Sundry Print Reports
04/29/2025

Well Name: LEU Well Location: T21S / R32E / SEC 5 / County or Parish/State: LEA /

Notice of Intent

Type of Action: Plug and Abandonment

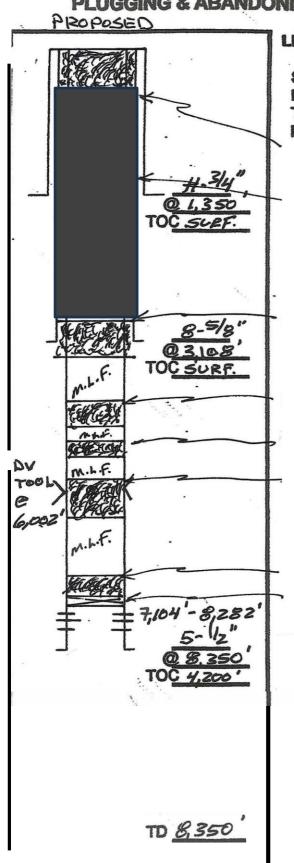
Set 51/2" CIBP @ 7,075'; circ. well

Pres. Test csg. to 500# x hold 30 mins.; run CBL

Pump (25) sx c. @ 7,075' - 6,905'; WOC x TAG

Pump Class C. @ 6,052' - 5,891' (51/2" DV); WOC x TAG

Pump Class C. @ 4,854' – 4,686' (CT/DLWZ)

Perf. x sqz. Class C. @ 3,613' - 3,462' (t/reef) TAG

Perf. x sqz. Class C @ 3,203' – 0' (Yates to Surface due To R-111Q) Verify Circulated to Surface

Cement		
Plug Type	Тор	Bottom	Length	Tag	Class	Notes	
Surface Plug	0.00	3203.00	3203.00	Verify			
Top of Salt @ 1310	0.00	3203.00	3203.00	Circulated to	CLASS C	CLASS C	Perf & Squeeze
11.75 inch- Shoe Plug	0.00	3203.00	3203.00	Surface			
8.625 inch- Shoe Plug	0.00	3203.00	3203.00				
Yates @ 3153	0.00	3203.00	3203.00				
Capitan Reef @ 3548	3462.52	3613.00	150.48	WOC & TAG	CLASS C	Perf & Squeeze	
Capitan Reel @ 3546	3402.52	3013.00	150.46				
Delaware @ 4784	4686.00	4854.00	168.00	WOC & TAG	CLASS C	Balanced Plug	
DV tool plug	5891.00	6052.00	161.00	WOC & TAG	CLASS C	Balanced Plug	
CIBP Plug	6095.00	7075.00	980.00	WOC & TAG	CLASS C	500psi leak test 30mins

No more than 2000' is to be allowed between plugs in open hole, and no more than 3000' between plugs in cased hole. Class H >7500' Class C<7500'

Fluid used to mix the cement in R111P shall be saturated with the salts common to the section penetrated, and in suitable proportions, but not more than 3% calcium chloride by weight of cement will be considered the desired mixture whenever possible.

High, Critical: Bottom of Karst to surface or Deepest fresh water, whichever is greater R111P: 50 Feet from Base of Salt to surface.

<u>50 Fee</u>	t from Base of Salt	to surface
Cave Karst/Potash Cement Requirement:	<u>R111-P</u>		
11.75 inch- Shoe Plug @	1350.00		
8.625 inch- Shoe Plug @	3108.00		
5.5 inch- Shoe Plug @	8350.00	TOC @	4200.00

Created By	Condition	Condition Date
gcordero	Run CBL to Surface	4/30/2025
gcordero	Spot 25 sacks cement 5600' - 5400' - T Cherry Canyon	4/30/2025
gcordero	A Cement Bond Log (CBL) is required to be submitted to electronic permitting.	4/30/2025
gcordero	Submit Cement Bond Logs (CBL) prior to submittal of C-103P.	4/30/2025
